Model: Apollon-C1 ARDF DF3010	Date: 5-Oct-07	No.: RB802001a
-------------------------------	----------------	----------------

Subject: The ARDF cover closes quickly		Prepared by: T.Kiyohara	
From: 1st Tech. Support Sec. Service Support Dept.			
Classification:	<input checked="" type="checkbox"/> Troubleshooting	<input type="checkbox"/> Part information	<input type="checkbox"/> Action required
	<input type="checkbox"/> Mechanical	<input type="checkbox"/> Electrical	<input type="checkbox"/> Service manual revision
	<input type="checkbox"/> Paper path	<input type="checkbox"/> Transmit/receive	<input type="checkbox"/> Retrofit information
	<input type="checkbox"/> Product Safety	<input type="checkbox"/> Other ()

Subject: ARDF 3010		Prepared by: N.Yoshida	
From: 2nd Tech Support Sec. Service Support Dept.			
Classification:	<input type="checkbox"/> Troubleshooting <input type="checkbox"/> Mechanical <input type="checkbox"/> Paper path <input type="checkbox"/> Product Safety	<input checked="" type="checkbox"/> Part information <input type="checkbox"/> Electrical <input type="checkbox"/> Transmit/receive <input type="checkbox"/> Other ()	<input type="checkbox"/> Action required <input t

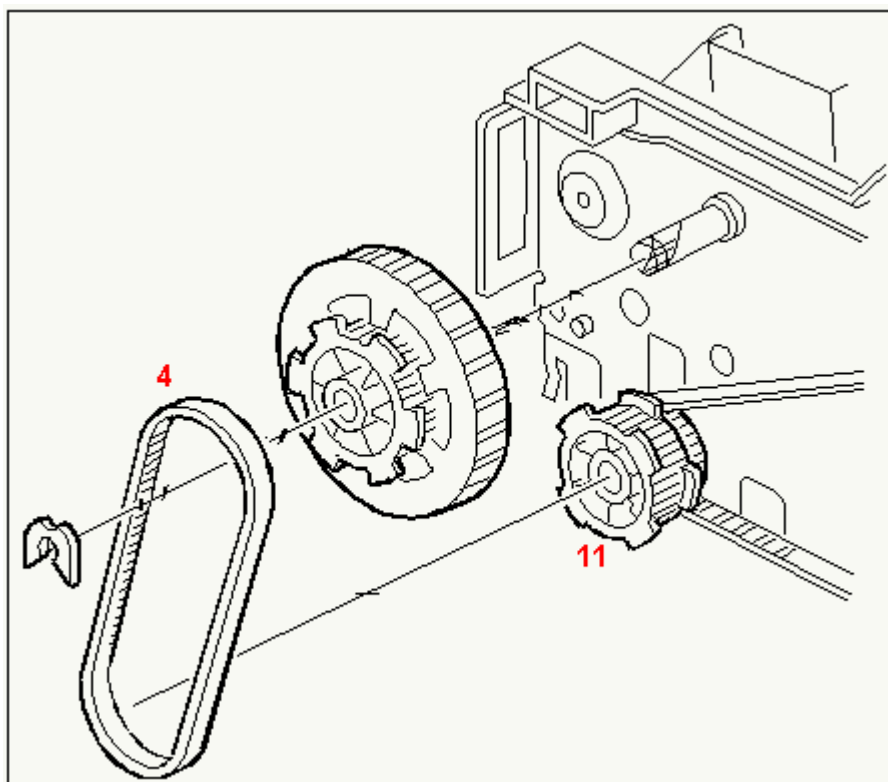
Old part number	New part number	Description	Q'ty	Int	Page	Index	Note
04513006	-	TAPPING SCREW - M3X6	2		27	101	
B8023234	B8023235	TIMING PULLEY:	1	X/O	31	11	A
B3121615	-	TENSION ROLLER			27	3	
B8021772	B8021774	TIMING BELT:40S3M186	1-1	X/X	27	4	A
B8021773	-	BRACKET:SHAFT:SIDE PLATE:FRONT	1		27	1

NOTE: When you install any of the parts labeled "A" in the table, make sure to install them **together as a set.**

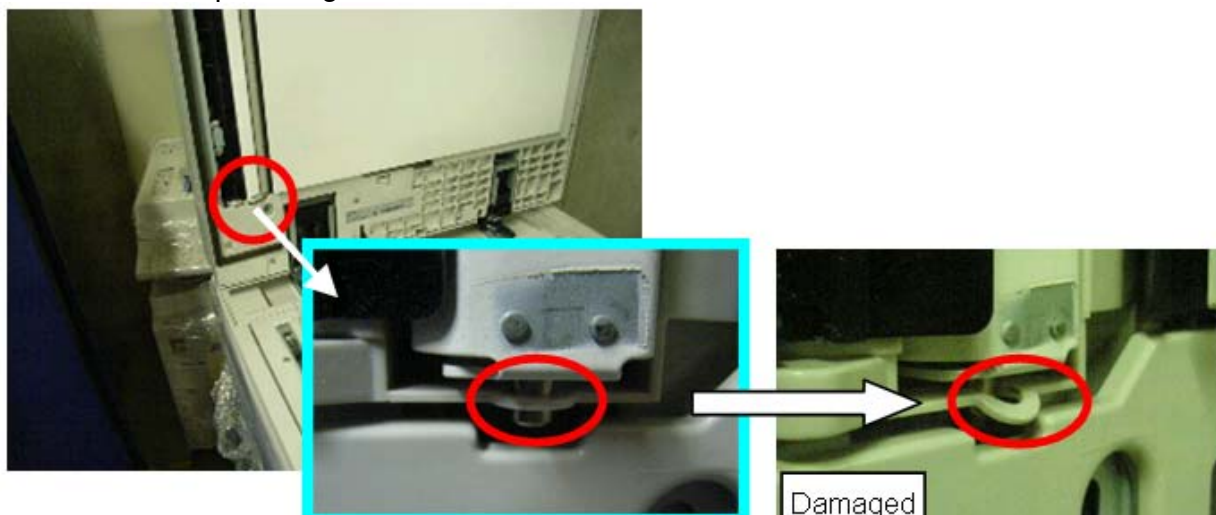
Symptom: ADF original feed Jam

The following circled part was bent because the customer inserted something like a pencil between the exposure glass and the ADF

1. If the unit serial number is earlier than shown in the following table, replace the following guide plate.

6.Original Transfer 2 (B802)

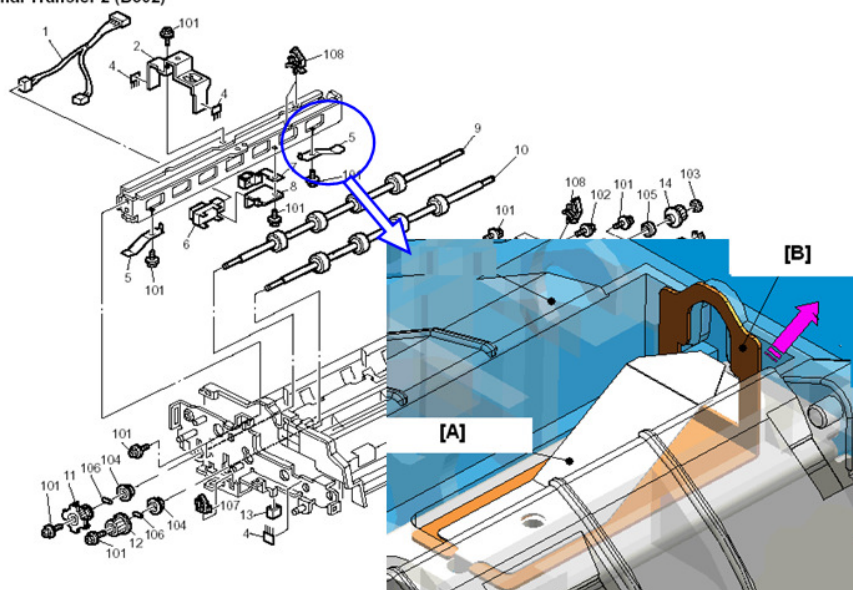
Old #	New #	Description	OLD Qty	NEW Qty	Int	Page	Index
B8023145	-	SPRING PLATE	2	1	X/O as a set	13	5
	B8023148	GUIDE PLATE:GUIDE PLATE:SCANNING	0	1		13	5
	B8023149	SPRING PLATE:GUIDE PLATE:SCANNING:INNER BACK	0	1		13	5

[A]: B8023149 [B]: B8023148

2. If the unit serial number is later than shown in the following table, it is unnecessary to replace the above parts because the frame parts were made stronger.

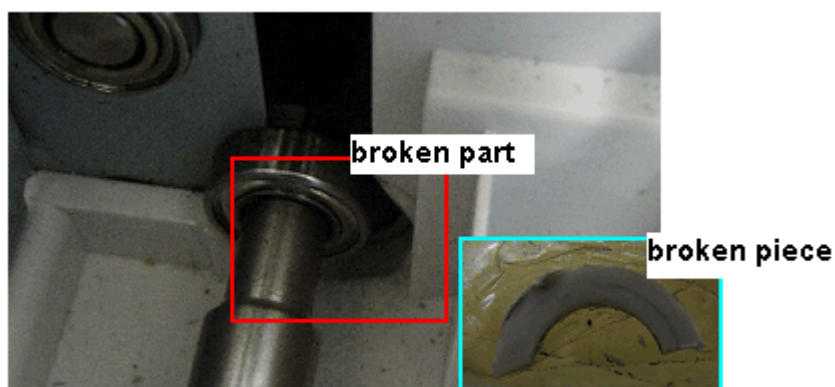
Original JAM 57 occurs frequently.

The following part is broken.

The bearing was modified (new P/N: #07413506), and applied to machines in production from the following serial numbers:

crack or broken piece

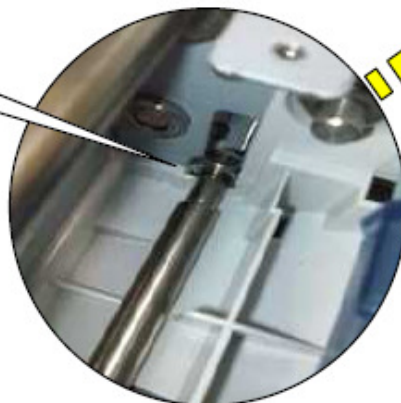
2. If there are any cracks in the following part (or broken pieces), go to Step 3.
